PIC16C77 Rev. A Silicon Errata Sheet

The PIC16C77 (Rev. A) parts you have received conform functionally to the Device Data Sheet (DS30390E), except for the anomalies described below.

Clarifications/Corrections to the Data Sheet:

FIGURE 1: WRITES TO TIMER1 (EXTERNAL CLOCK/OSCILLATOR MODE)

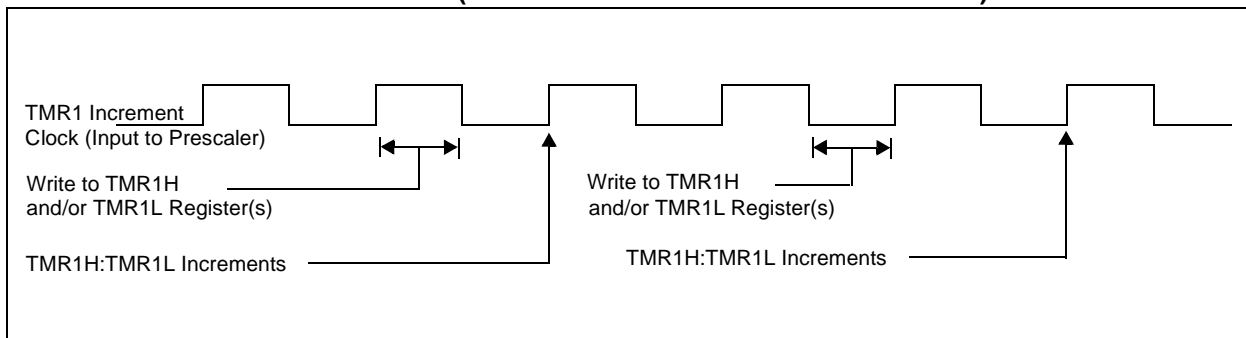
The operation of Timer1 needs some clarification when the timer registers are written when the TMR1ON bit is set.

The internal clock signal that is the input to the TMR1 prescaler affects the incrementing of Timer1 (TMR1H:TMR1L registers and the Timer1 prescaler). When the Timer1 registers are NOT written, the Timer1 will increment on the rising edge of the TMR1 increment clock.

When the TMR1H and/or TMR1L registers are written while this clock is high, TMR1 will increment on the next rising edge of this clock.

When the TMR1H and/or TMR1L registers are written while this clock is low, TMR1 will not increment on the next rising edge of this clock, but must first have a falling clock and the rising clock, for TMR1 to increment.

Figure 1 shows the two cases of writes to the TMR1H and/or TMR1L registers. Due to the V_{IH} and V_{IL} thresholds on the oscillator/clock pins, external Timer1 oscillator components, and external clock frequency, the Timer1 increment clock may not be of a 50% duty cycle.

The TMR1 increment clock is out of phase of the T1OSO/T1CKI pin by a small propagation delay.
